## Proposal Content Document

| <b>Proposal title</b>    | Marri Wind Farm  |
| <b>Proponent name</b>    | Marri WF Pty Ltd   |

Author: Carmen Liang | Date: 12/05/2026 | C:\Users\Carmen.Liang\Aurecon Group\525974 - Dandaragan Wind Farm - 4. GIS\ProJERD\_APRX | Fig1-2

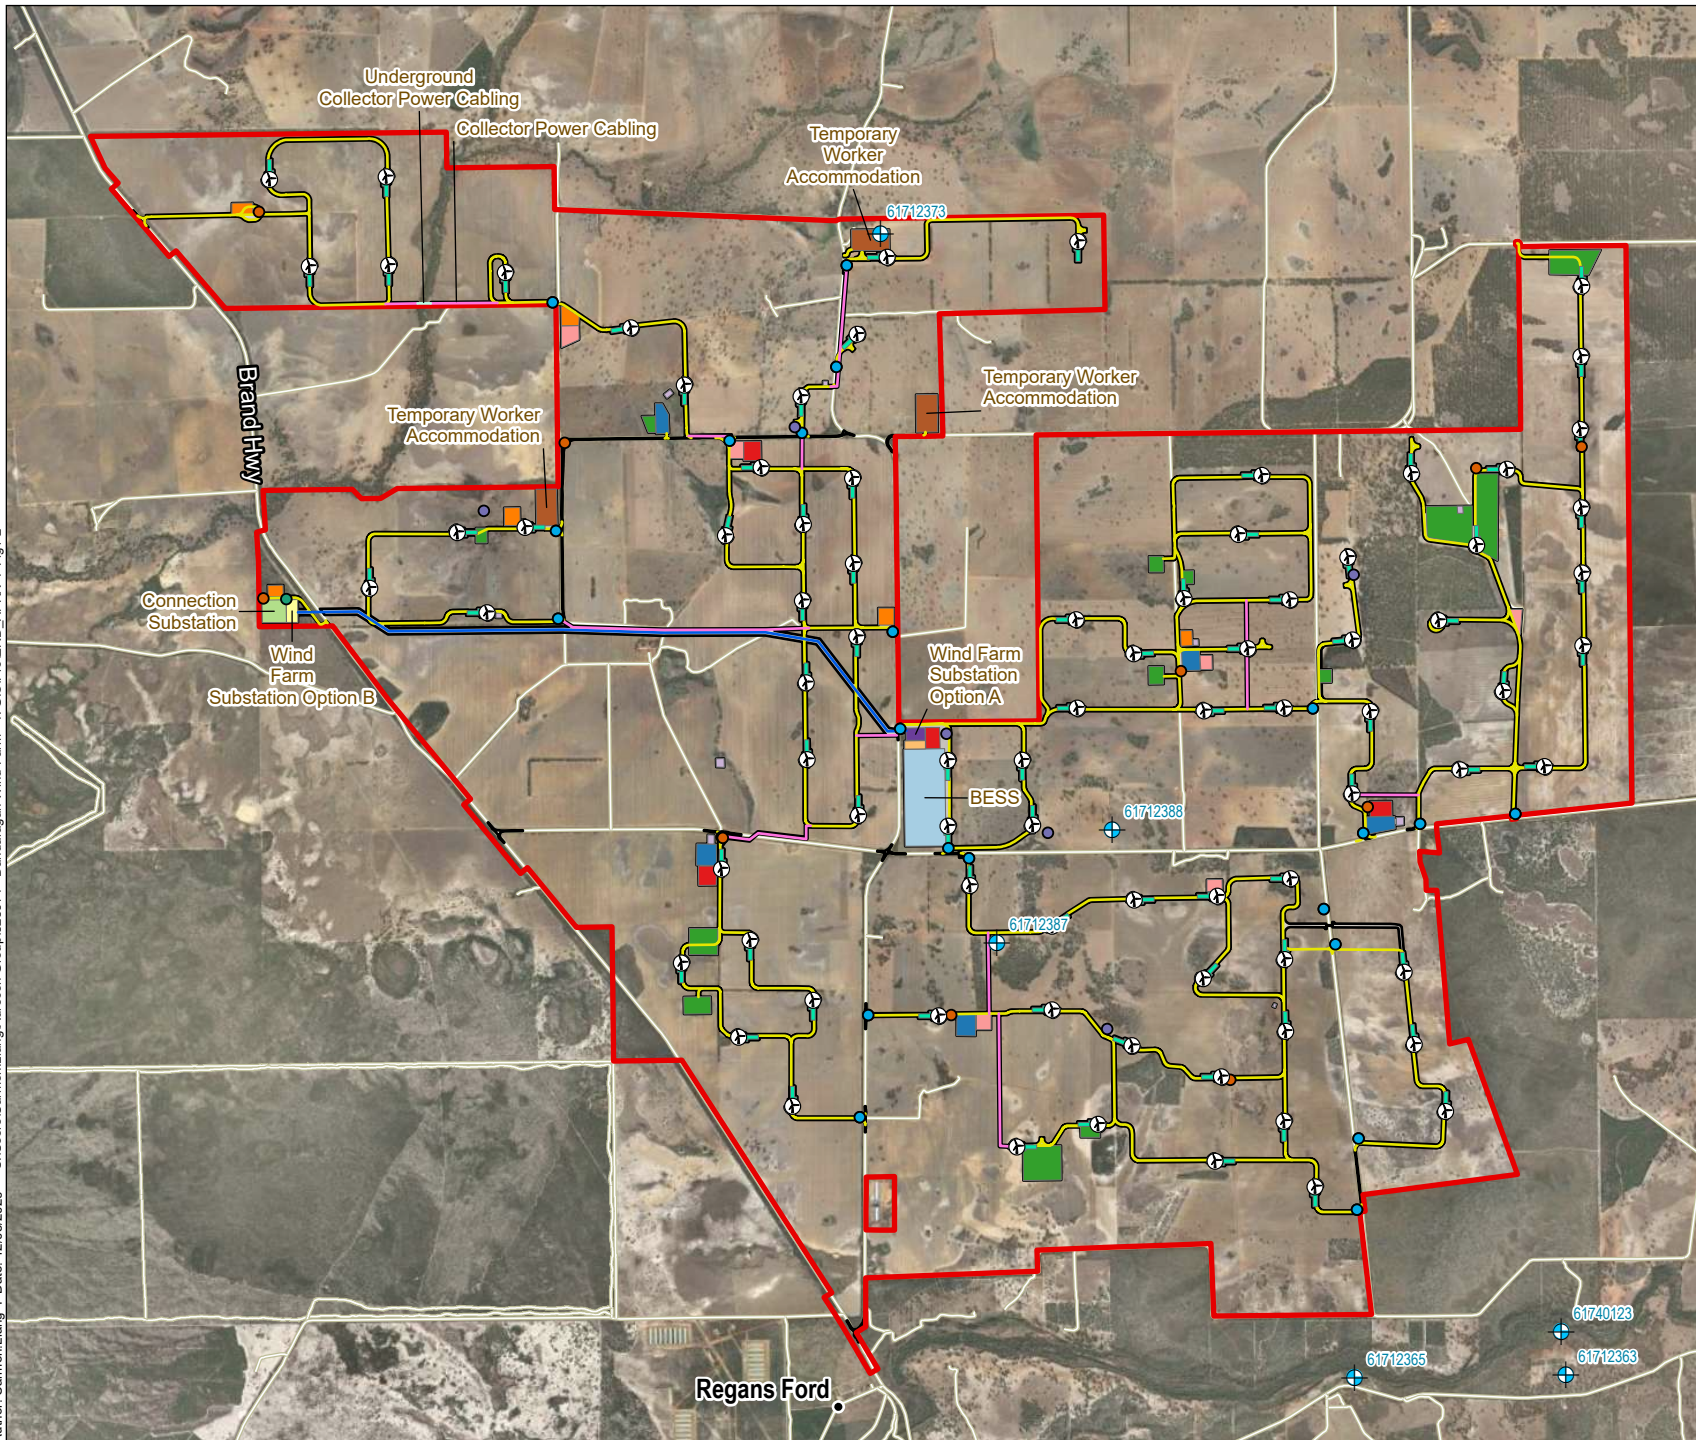
| Permanent meteorological masts<br>Permanent communication tower  |   |  | Reduced clearing of native vegetation by 76.98 ha.<br>Figure 1-2 Amended Proposal  | <ul style="list-style-type: none"> <li>4.08 ha of native vegetation. This includes the 0.168 ha of TEC.</li> </ul>   |

Author: Carmen.Liang | Date: 12/05/2028 | C:\Users\Carmen.Liang\Aurecon Group\525974 - Dandaragan Wind Farm - 4. GIS\ProJRD\_APRX | Fig1-3\_overview

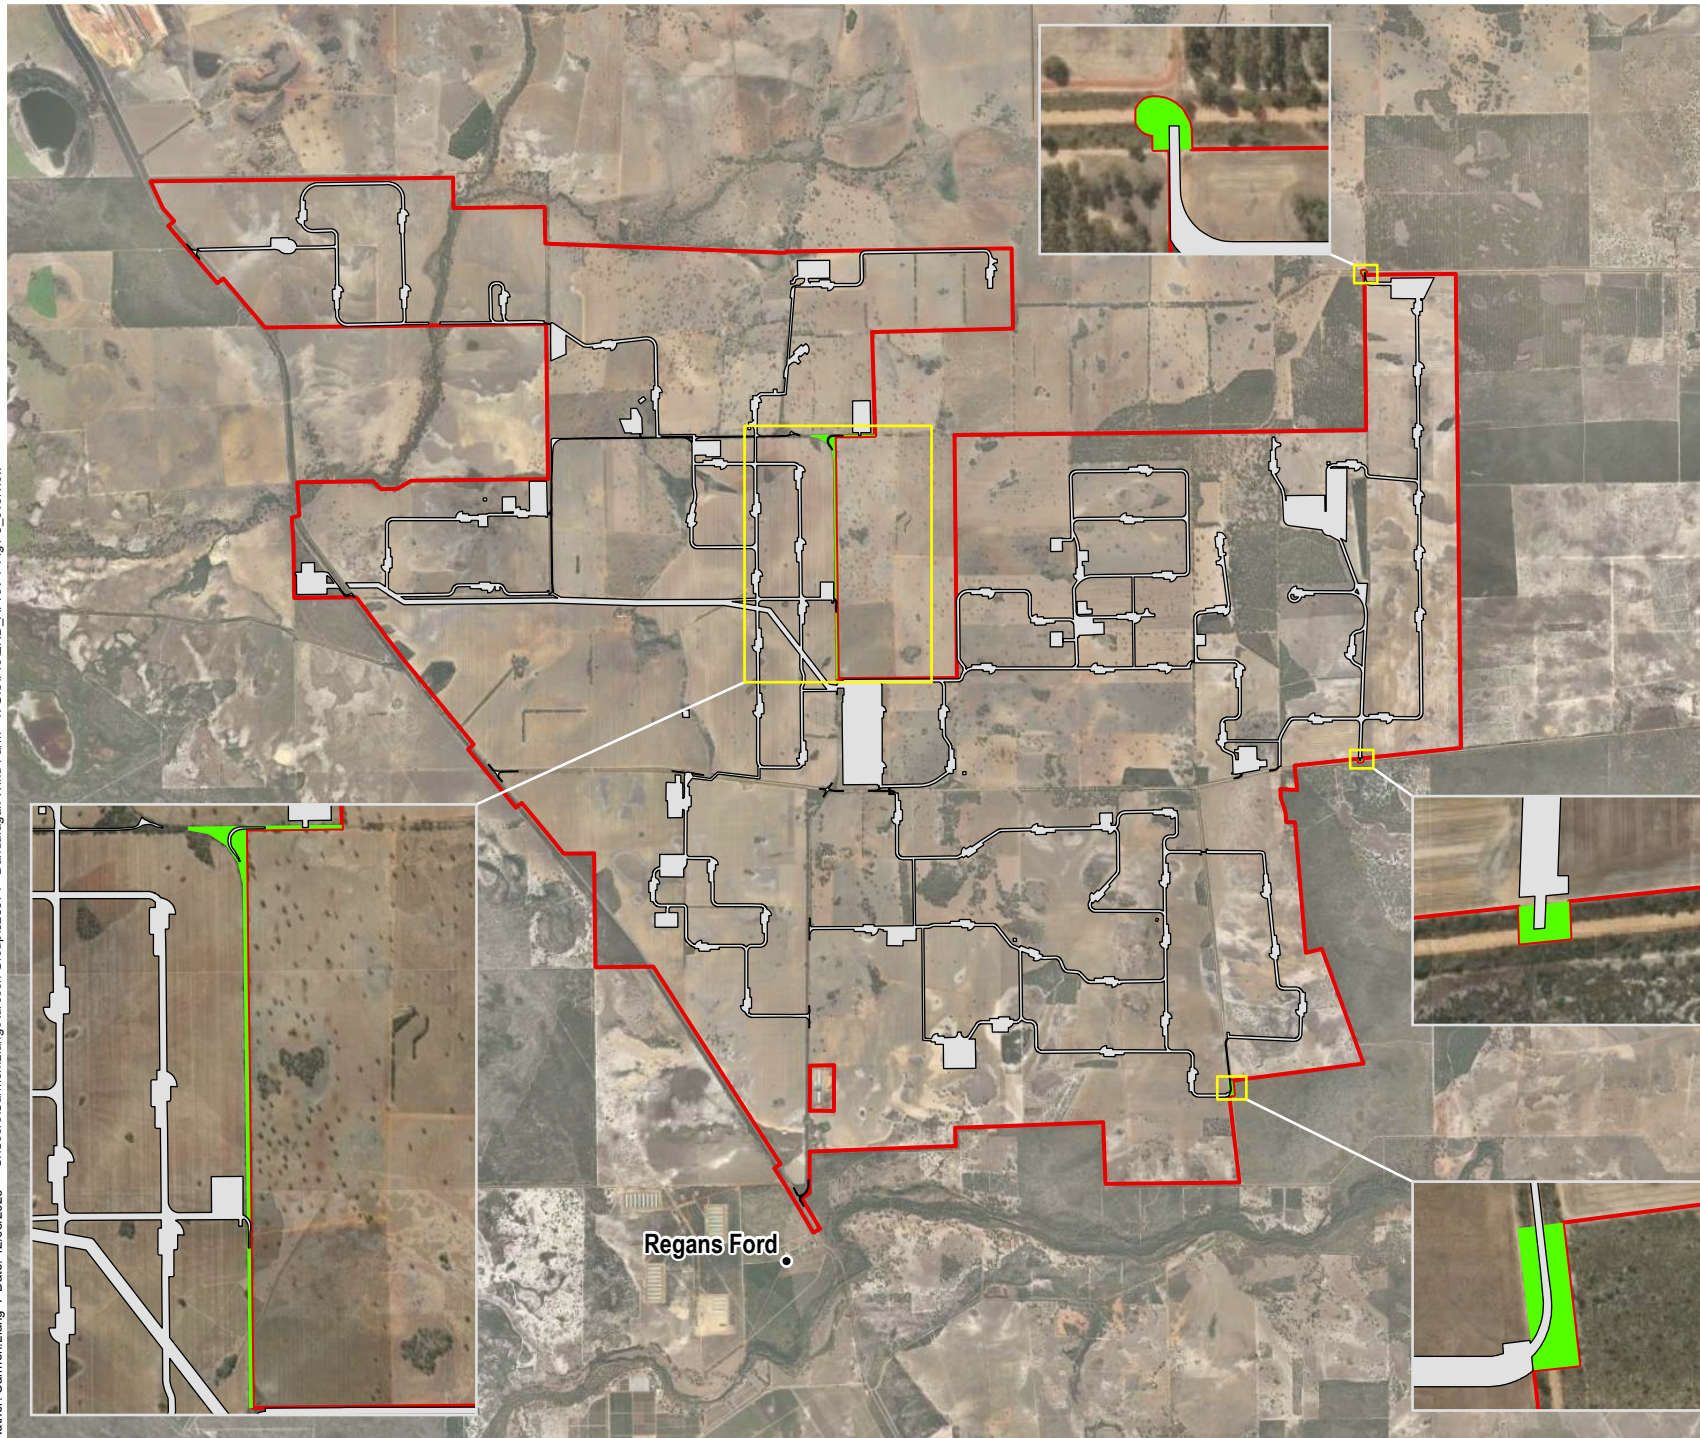
| Proposal elements  | Location and description  | Existing proposal extent, capacity or range                 | Proposed amendment<br>(Content of section 38C, 43A or 45C amendment)  | Combined extent, capacity or range<br>(total of existing approval +proposed change)   |
|--|---|---|---|---|
| Development Envelope includes the Indicative Disturbance Footprint with the following features | Within the Development Envelope<br>Figure 1-1:<br>Proposal Location | Proposed Development Envelope of approximately 12,473.12 ha | The Development Envelope has been amended to account for 0.98 ha of potentially impacted vegetation located outside of the previous Development Envelope.<br><br>The overall area of the Development Envelope has increased by 10.43 ha.<br><br>The proposed Indicative Disturbance Footprint has increased by 0.76 ha. | Proposed Development Envelope of approximately 12,483.55 ha<br><br>Proposed Indicative Disturbance Footprint of approximately 964.37 ha<br><br>The total native vegetation that will be cleared as a result of the Proposal is 7.02 ha which comprises:<br><br>• Up to 2.94 ha of scattered native trees within the Agricultural lands. |

| External site access<br>Internal access roads or tracks<br>Clearing to necessitate site entry  |   |  | Figure 1-3 (and subfigures) Proposed Amendments  |  |
